24ITB007 280 Door Replacement (Rebid)

Addendum #1 (Revision to Section II - Scope of Services and Questions & Answers)

Issued: 11/20/2023

1. Main Facility Entrance Doors

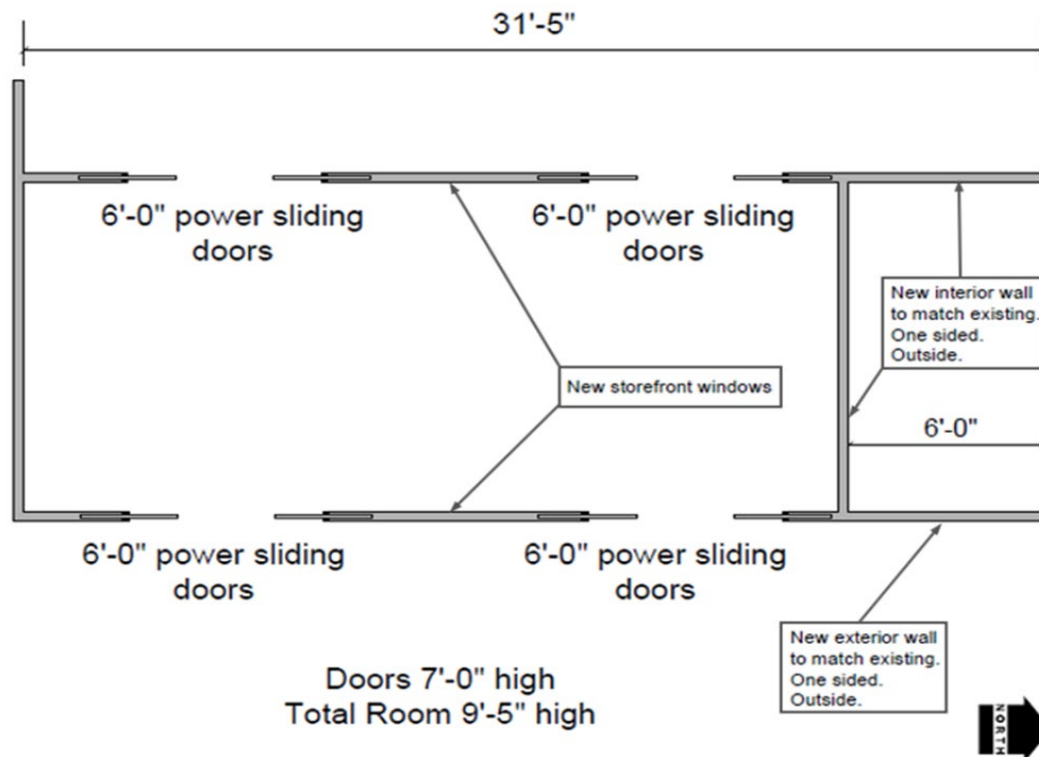
Section II.A.1, Main Facility Entrance Doors, is hereby deleted in its entirety and replaced with the following:

- Remove and haul away existing electric sliding doors and hardware.
- Provide and install two sets of new electric sliding doors and all necessary hardware, sensors, and controls (new Drawing follows).
- New electric sliding doors shall enable smooth, efficient, and safe entry and exit for high pedestrian traffic.

Q2-2	11/20/2023 9:14 AM	The owners new drawing appears to create 6’ x 20’ cavity, will fire suppression be required for this room?	<i>The referenced area has a sprinkler.</i>
Q2-3	11/20/2023 9:14 AM	Please confirm ingress / egress calculation is not impacted by the removal of a portion of the storefront?	<i>Removing a portion of the storefront will not impact the ingress/egress calculation.</i>
